GE Energy

MFN 06-135

Docket No. 52-010

**Subject: Partial Response to RAI Letter Numbers 20 and 27 Related to ESBWR Design Certification Application – Seismic Design – DCD Sections 2.5 and 3.7 – RAI Numbers 2.5-2 through 2.5-7; 3.7-1 through 3.7-4, 3.7-6, 3.7-9, 3.7-10, 3.7-13 through 3.7-15, 3.7-17 through 3.7-23, 3.7-28, 3.7-31, 3.7-36, 3.7-40 through 3.7-49, 3.7-51, 3.7-53, and 3.7-56**

JULY 21, 1982

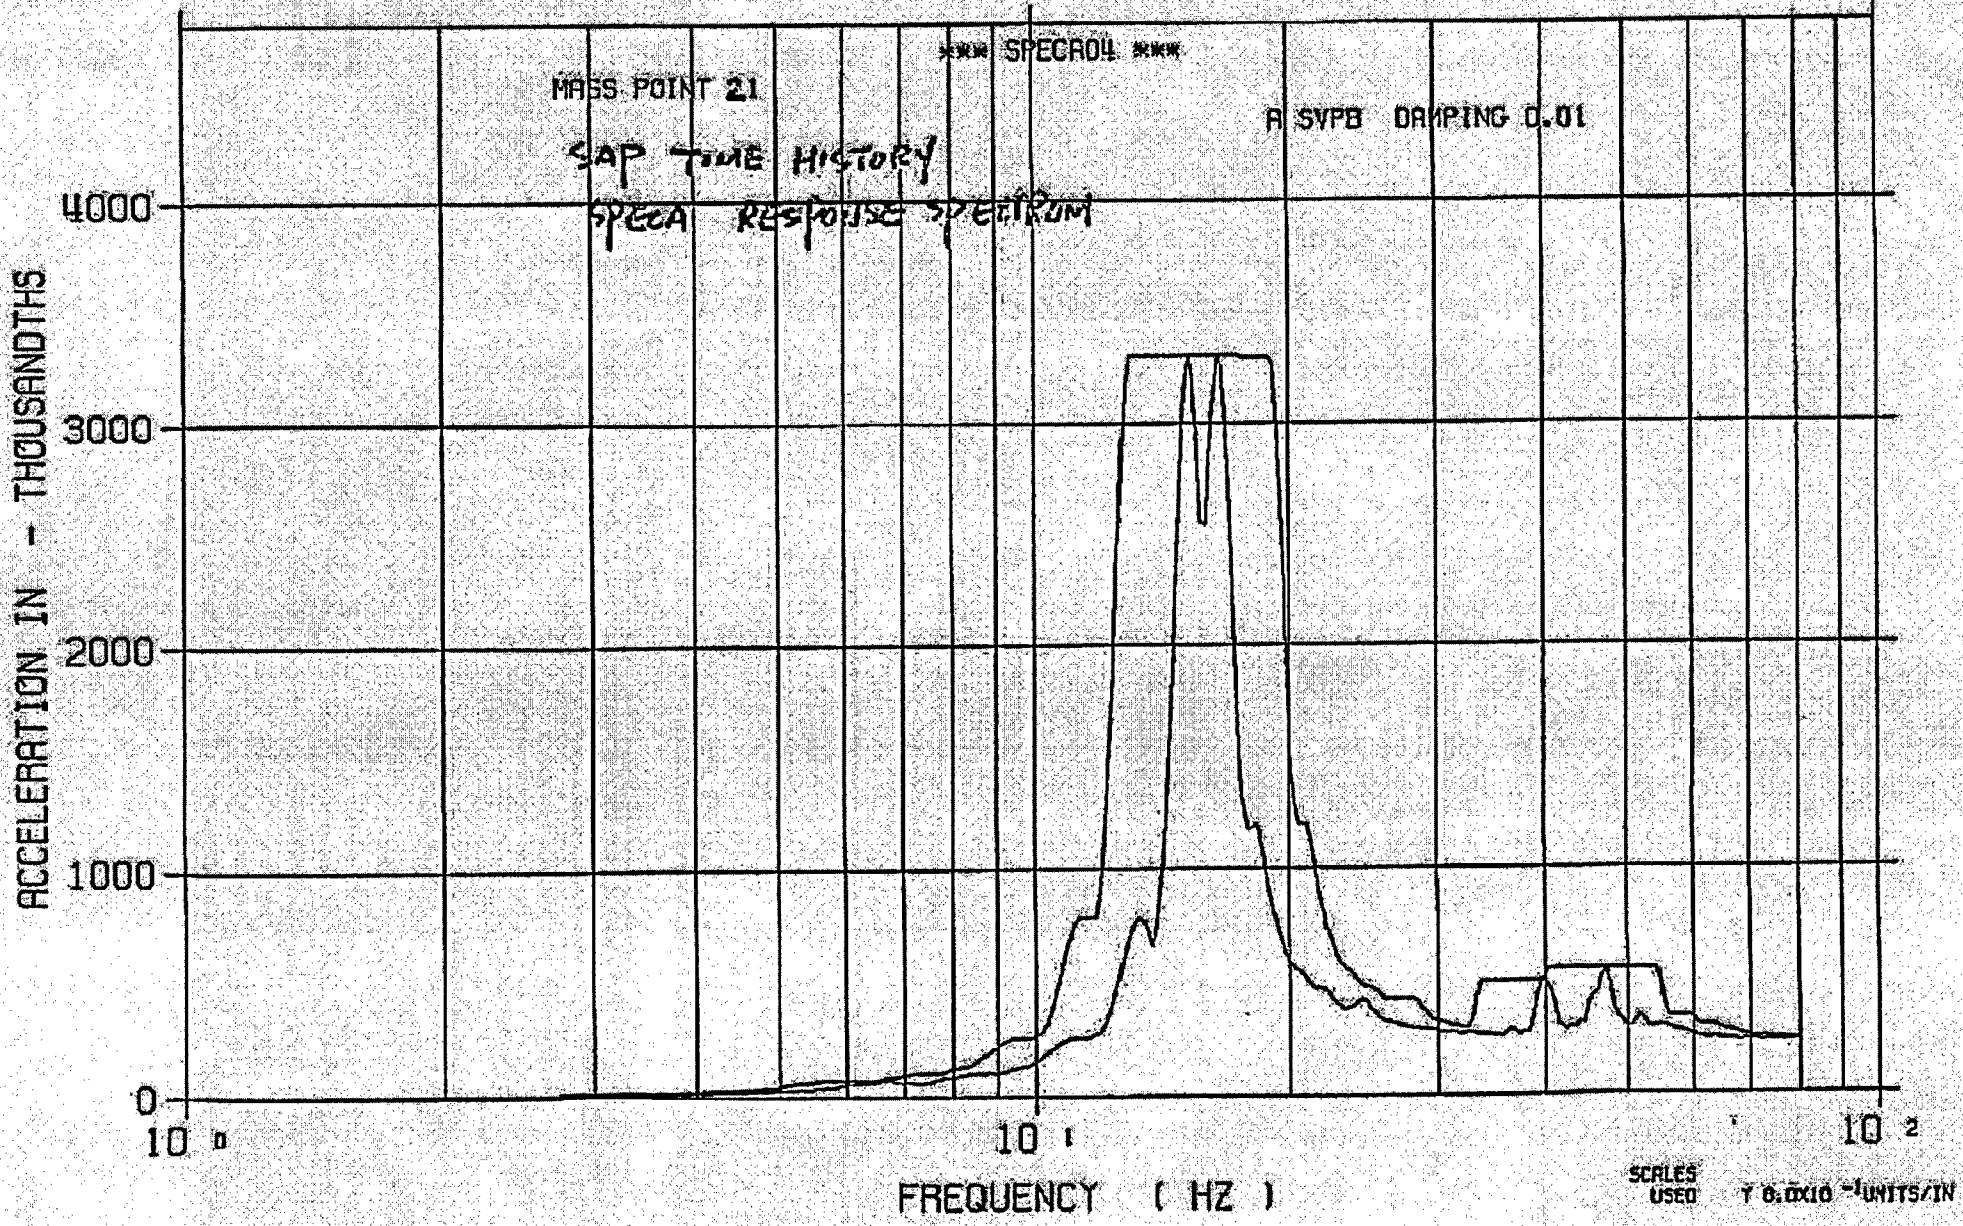
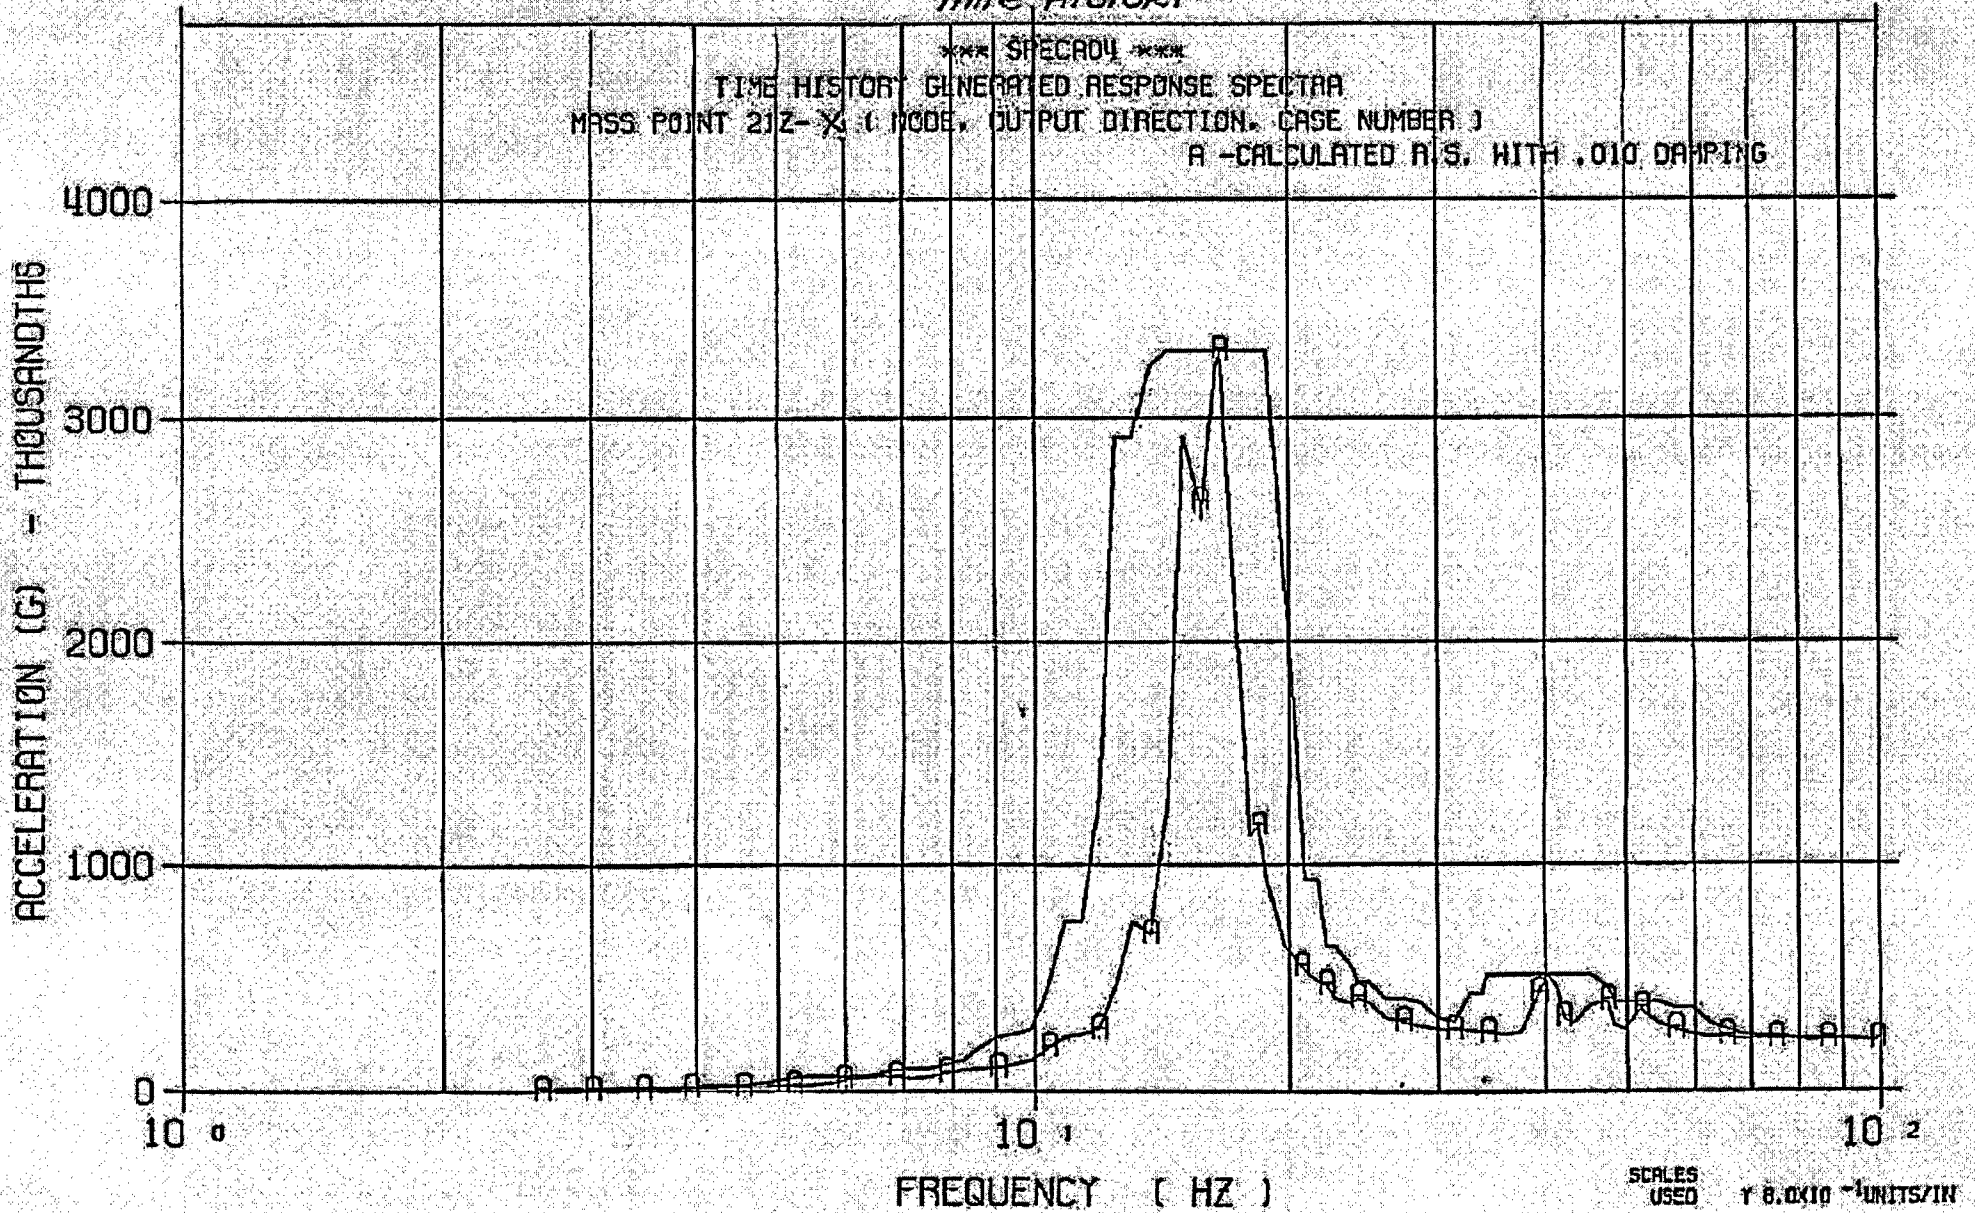
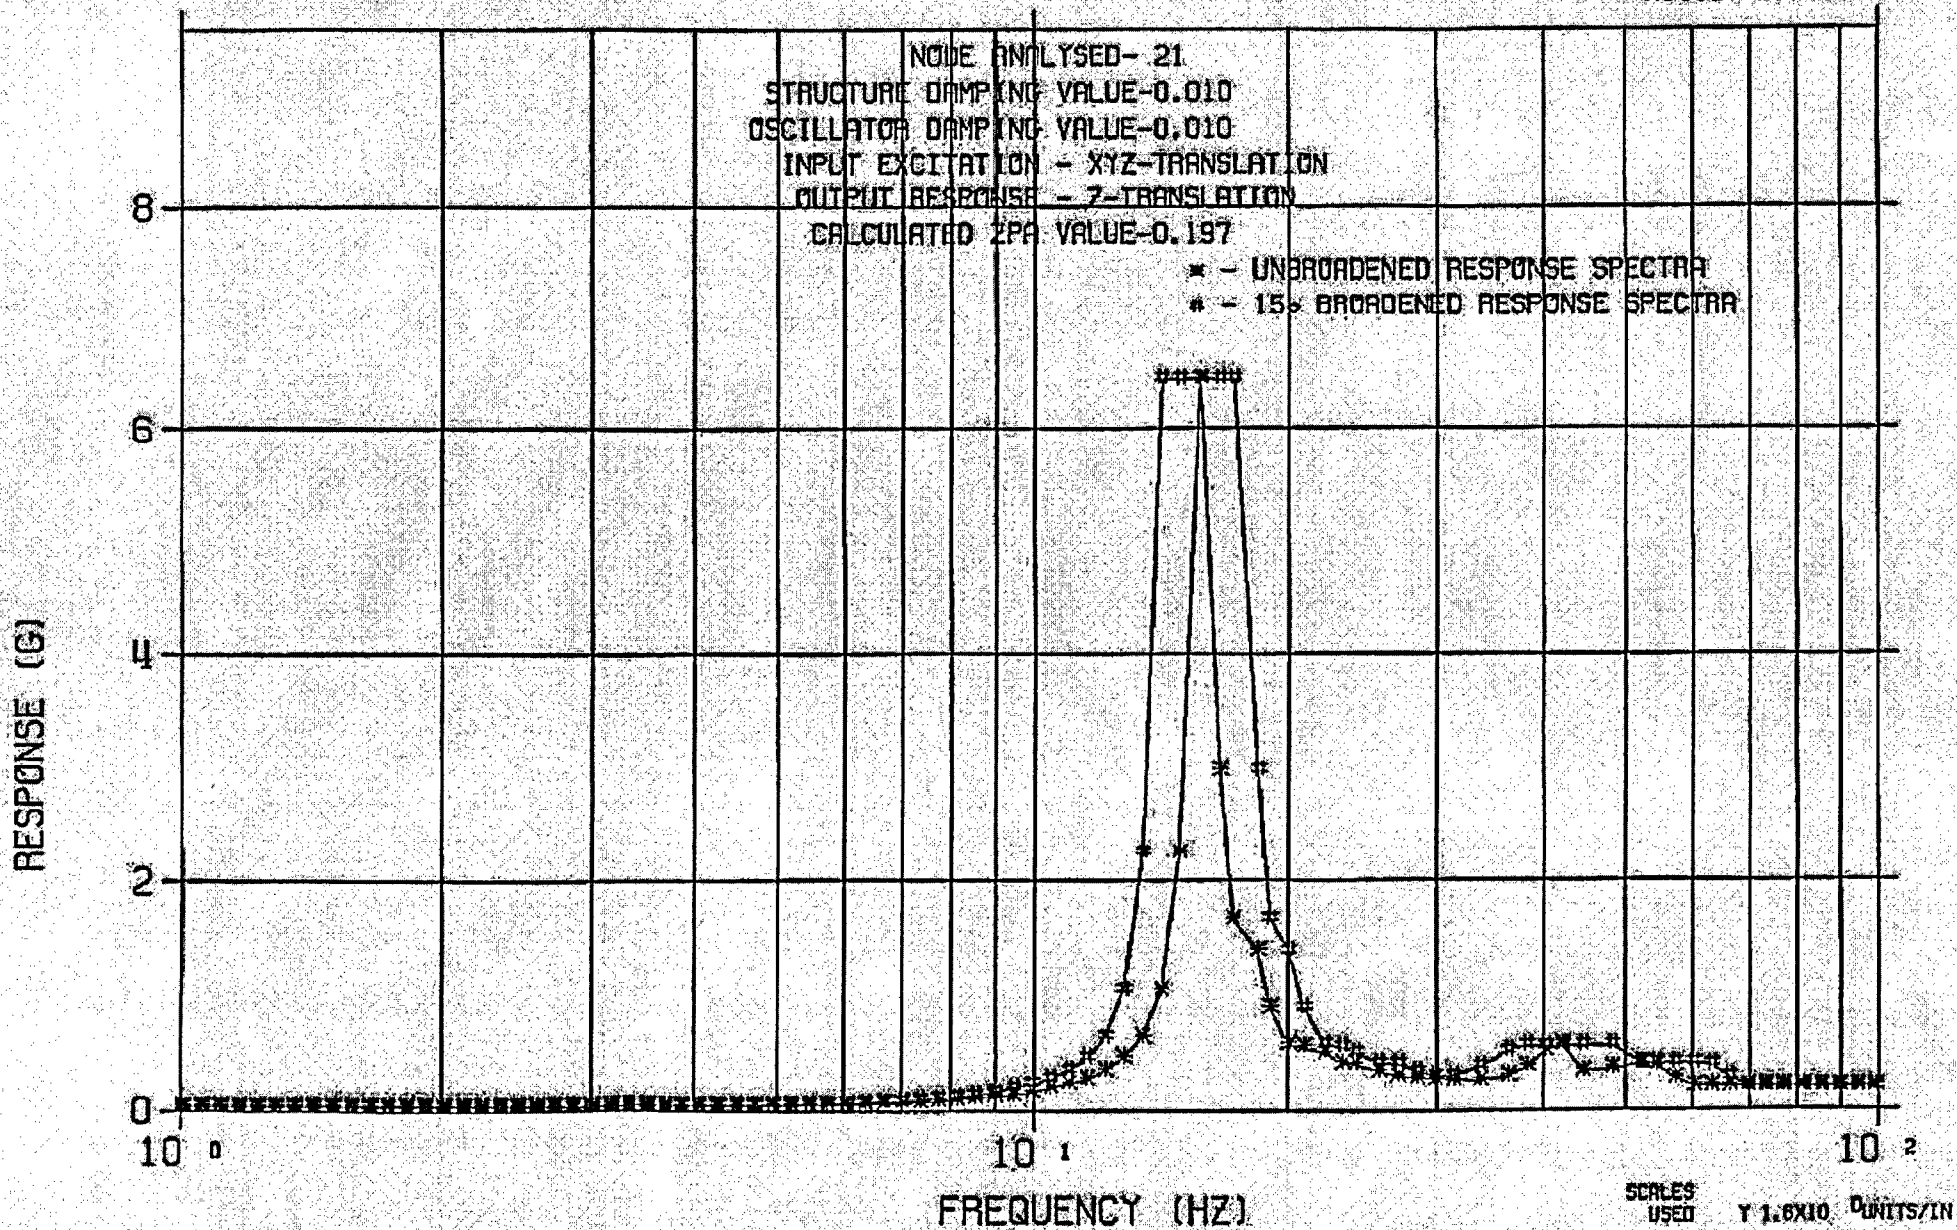
*DCD Appendix 3D (3D.4.6.1) identifies the ERSIN Computer Program, which provides direct generation of local or global acceleration response spectra. Its stated use is to generate response spectra for pipe-mounted and floor-mounted equipment. To facilitate the staff's evaluation of this computer code, the applicant is requested to submit a validation package for the specific types of ESBWR applications, including comparisons to response spectra generated by time history analysis.*

Numerical results, including response spectrum plots, of the comparative analyses considered in the verification of the ERSIN computer code are provided in the attachment.

The plots presented show clearly that the ERSIN03 time history results are only slightly different from the SAP4G07 time history results in all directions. Further the ERSIN03 Response Spectra results are conservative to the time history results in all frequency ranges.

The ERSIN program effectively calculates an accurate time history and only slightly conservative response spectra values for SRV load case.
